**Economic and Social Council**Distr.: General  
19 June 2015

**Economic Commission for Europe****Inland Transport Committee****World Forum for Harmonization of Vehicle Regulations****Working Party on Noise****Sixty-second session**

**Regulation No. 28 (Audible warning devices)****Proposal for Supplement 5 to Regulation No. 28****Submitted by the expert from the Russian Federation\***

## II. Arrangement of the approval mark of vehicle with regard to its audible signals

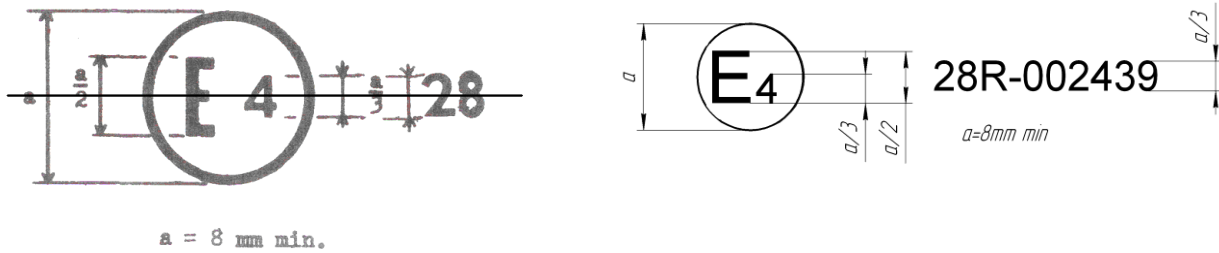
The above approval mark affixed to a vehicle indicates that, pursuant to Regulation No. 28, this vehicle type has been approved in the Netherlands (E 4), with regard to its audible signals. **The first two digits of the approval number indicate that Regulation No. 28 was in its original form.**

### Model B

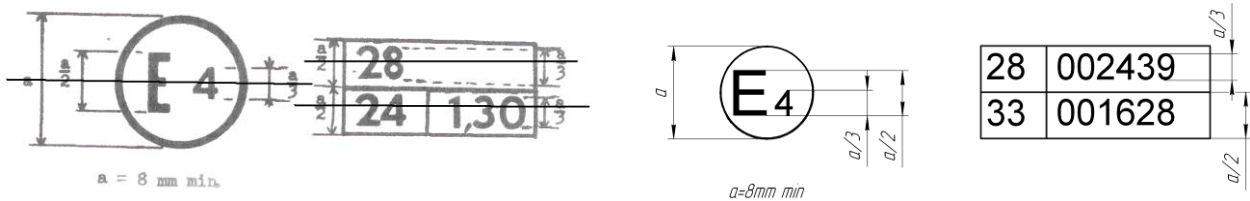
The above approval mark affixed to a vehicle indicates that, pursuant to Regulations Nos. 28 and 24 33, this vehicle type has been approved in the Netherlands (E 4), with regard to its audible signals and to emissions of pollutants by the Diesel engine. In the case of the latter Regulation, the corrected value of the absorption factor is  $1.30 \text{ m}^{-1}$ .

**Microphone positions for measurements acoustics parameters of audible warning devices**

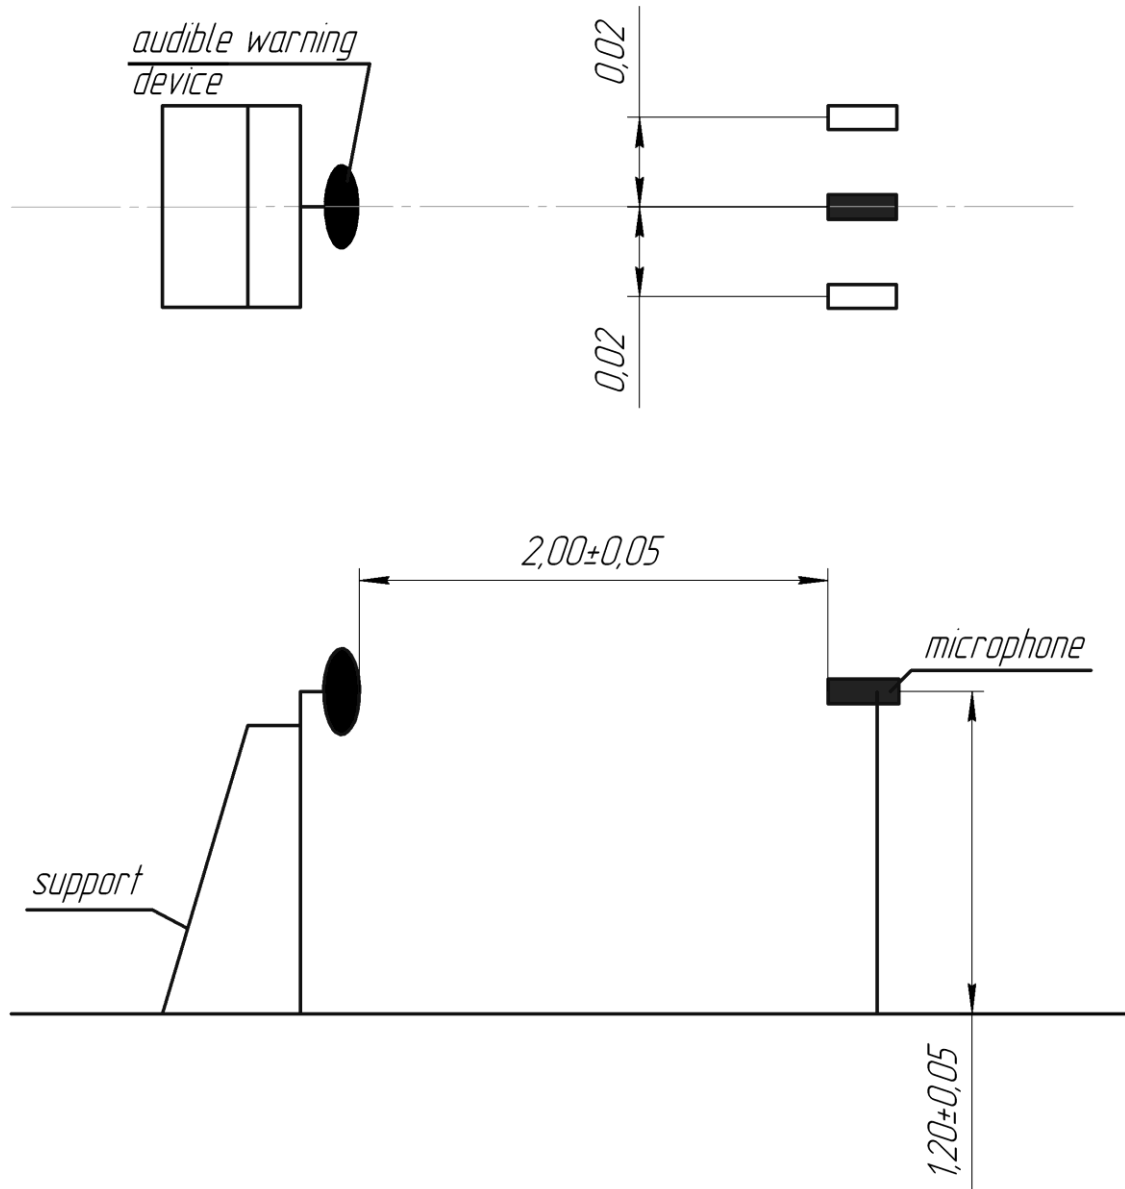
The microphone shall be so placed that its diaphragm is at a distance of ~~2.00 ± 0.01~~ **0.05** m from the plane of the sound outlet of the device. **The microphone must be positioned facing the front surface emitting sound of the warning device in the direction in which the maximum sound level can be measured. See figure in Annex 4.**

### Microphone positions for measurements audible signals of motor vehicles

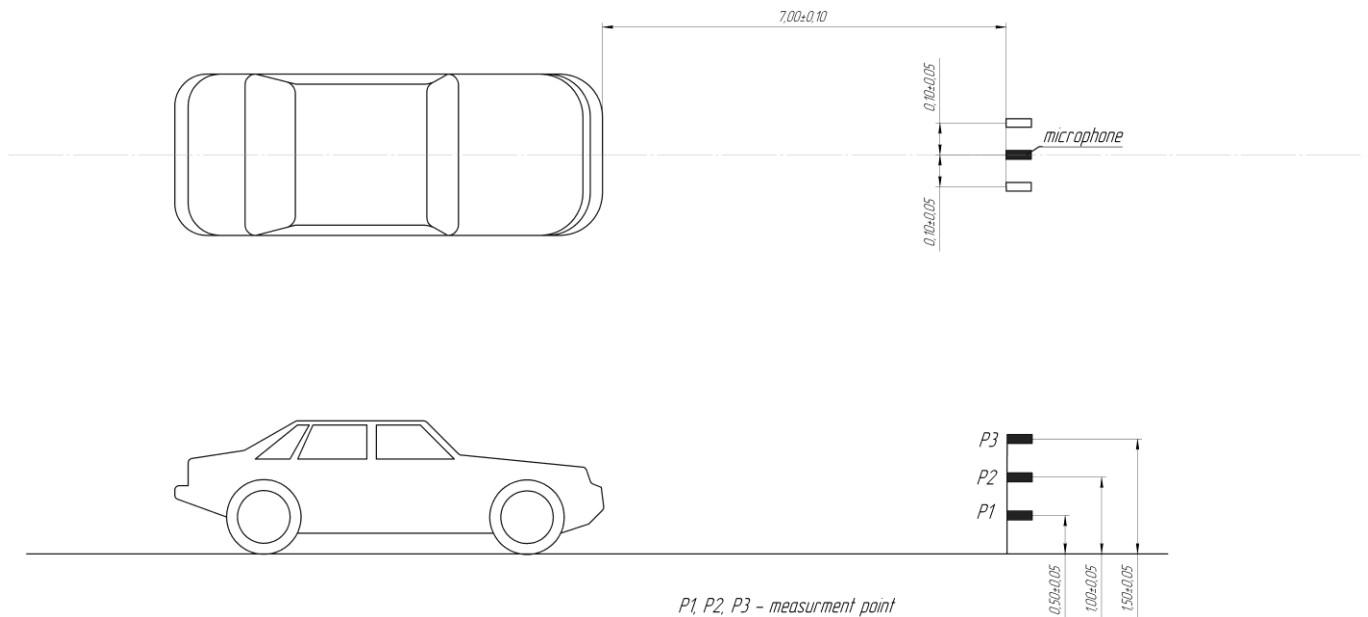
1. Sections 7, 10, 15, 19 reflect the change of headers. A new section 18 is added. New Annexes 4 and 5 are added with graphical information.
